City of El Paso – City Plan Commission Staff Report

Case No:	SUSC13-00006 Montecillo Unit Six
Application Type:	Major Preliminary
CPC Hearing Date:	April 10, 2014
Staff Planner:	Nelson Ortiz, (915) 541-4931, ortiznx@elpasotexas.gov
Location:	West of Mesa and South of Carousel
Acreage:	15.749 acres
Rep District:	8
Existing Use:	Vacant
Existing Zoning:	SCZ (Smartcode; T1, T3, T4, T4O)
Proposed Zoning:	SCZ (Smartcode; T1, T3, T4, T4O)
Nearest Park:	Playground proposed within subdivision
Nearest School:	Morehead Middle School (.59 mile)
Park Fees Required:	N/A
Impact Fee Area:	N/A
Property Owner:	EPT Mesa Development East, L.P.
Applicant:	EPT Mesa Development East, L.P.
Representative:	Conde, Inc.

ATTACHMENT 3

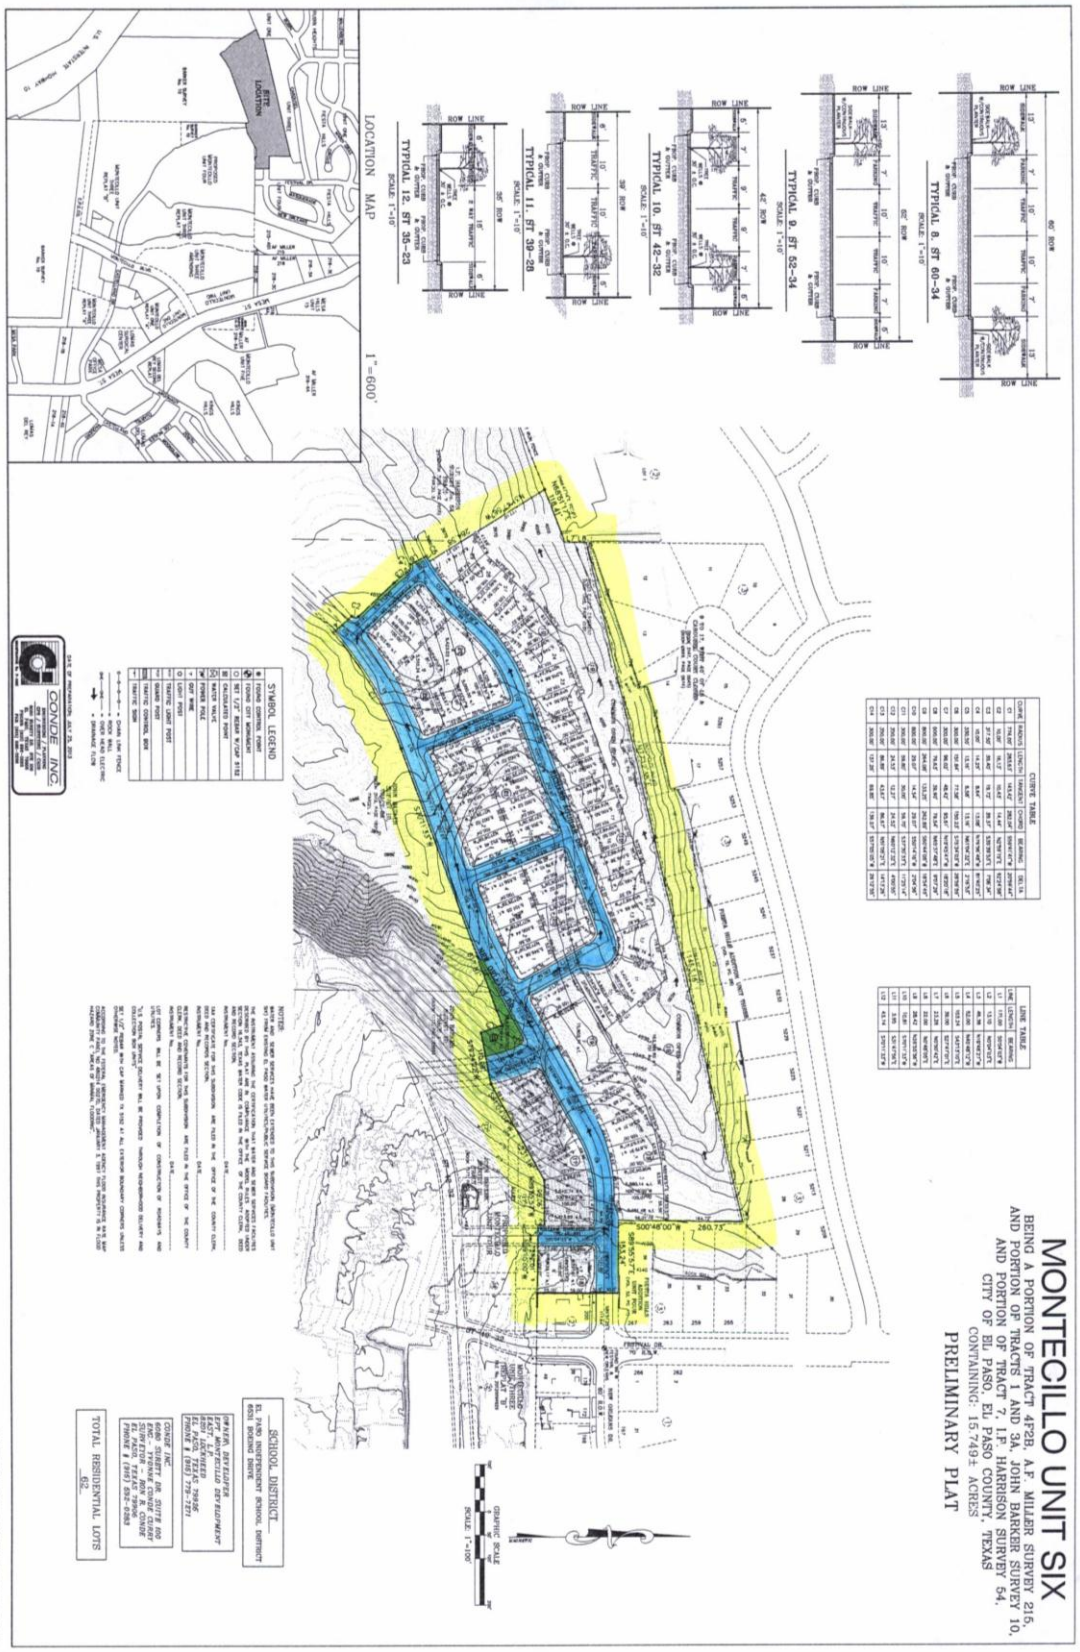
1. Show the drainage flow for the alley and the drainage right-of-way.
2. The stormwater seem to flow outside of this Plat; the developer shall be responsible for maintenance of all offsite stormwater management facilities unless drainage easements or rights-of-way with adequate access are provided for the EPWU Stormwater Utility.

1. Playground area: Lot 1, Block 23
    a) Per meeting discussions, applicant has offered to enlarge the boundary limits large enough to accommodate at least a 50'x50' area for the playground structure.
    b) Parks requests that during the playground area design, a 4'- 6' high safety fence be introduced all along the entire boundary line due to the close proximity of the proposed playground area to the street and the hazards of the road traffic to prevent a child from inadvertently running into the traffic or steep slopes (nearby hazards) as per The Consumer Product Safety Commission (CPSC) standards.

1. Areas noted as "Common Open Space" (Lot 9, Block 19) shall be cleaned and free of trash & all manmade sloped / disturbed areas shall be re-vegetated with desert plants

1. *The EPWU cannot commit to provide sewer service at this time.*
2. *Sanitary sewer service to the subject development is critical*
3. *EPWU has reviewed preliminary sewer designs from the Owner/Developer's Engineer. EPWU has identified several segments of the preliminary designs which present inadequacies such insufficient main cover, excessive depths of the mains. EPWU respectfully requests further information and further coordination prior to EPWU agreement to provide service.*

Addressing shall be displayed on the plat.

1. Submit to the City Development Department – Planning Division the following prior to recording of the subdivision.
    a. Current certified tax certificate(s)
    b. Current proof of ownership
    c. Release of access document, if applicable
    d. Set of restrictive covenants, if applicable
2. Every subdivision shall provide for postal delivery service. The subdivider shall coordinate the installation and construction with the United States Postal Service in determining the type of delivery service for the proposed subdivision. In all cases, the type and location of delivery service shall be subject to the approval of the United States Postal Service.
3. Applicant shall change the street name Pat Aduato Drive to Castellano Drive.
